**IT-010-21**

**March 26, 2021**

**Response to Questions**

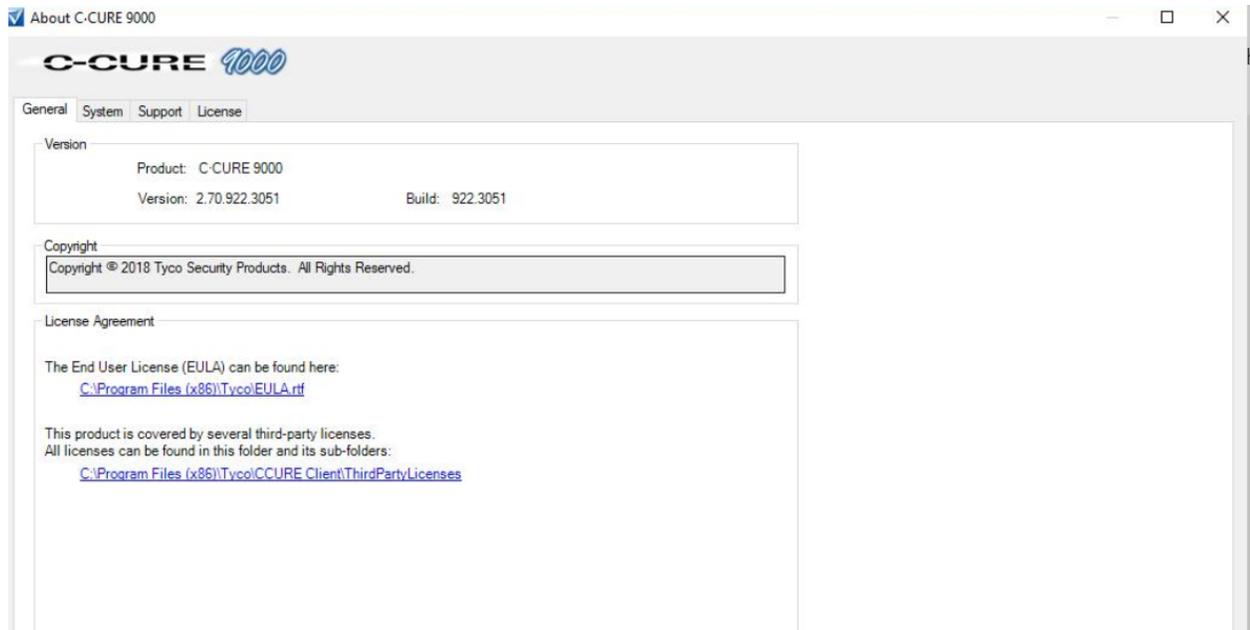
13. Can you confirm the door access system, I know the controller model was a 9000 but I am looking to verify they system name, also please confirm if we need to include door strike hardware, based on the talk we had in the parking lot I am under the impression we are only providing the controller and readers at the doors.

Answer: Answer: Below is the system information. Please include door strike hardware for all card reader doors.
